IN THE DRAWINGS:

REMARKS

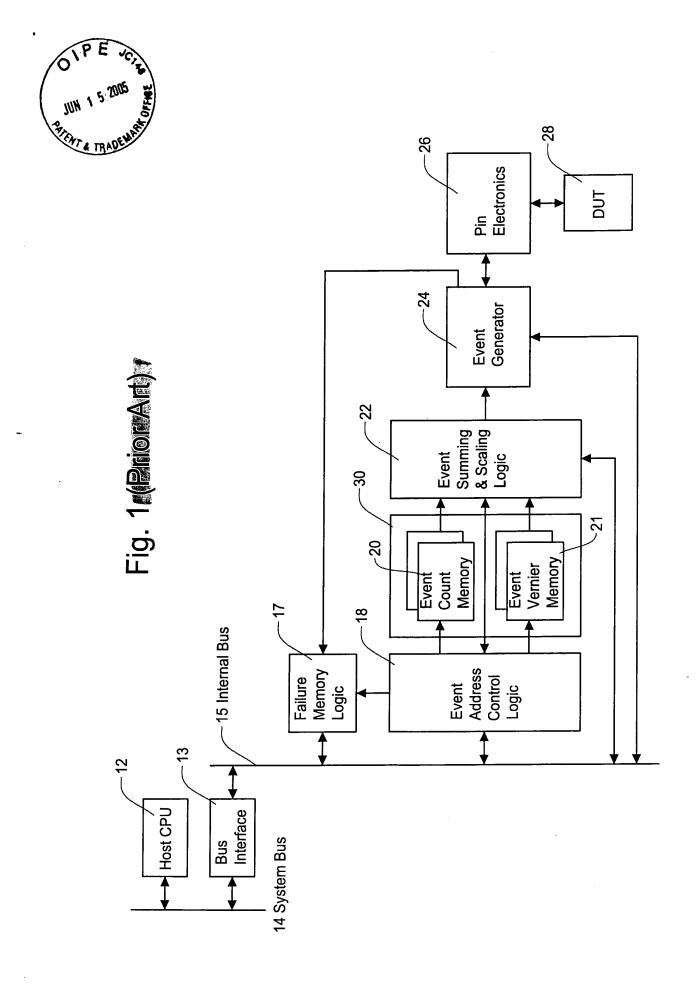
In the office action, the examiner objected to the drawings on the ground that Figures 1 and 2A-2D lack a "Prior Art" label. Accordingly, the applicant has submitted concurrently herewith a request for approval of drawing changes in which a "prior art" label is added to Figures 1 and 2A-2D to overcome the objection by the examiner. In this opportunity, the applicant has amended the drawings to add reference labels indicating registers of pipelines to Figures 14, 17-18, 22 and 25. The applicant has also submitted replacement sheets for the amended drawings.

Fig. 14

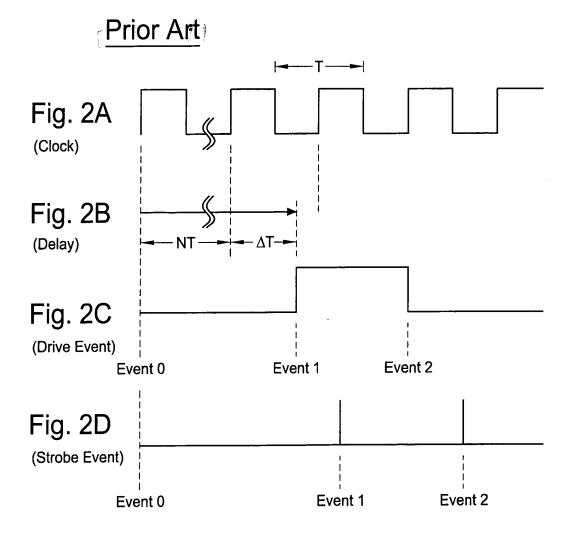
The applicant has submitted concurrently herewith a request for approval of drawing changes in which a "prior art" label is added to Figures 1 and 2A-2D to overcome the objection by the examiner and reference labels indicating registers of pipelines are added to Figures 14, 17-18, 22 and 25. The applicant has also submitted replacement sheets for the amended drawings.
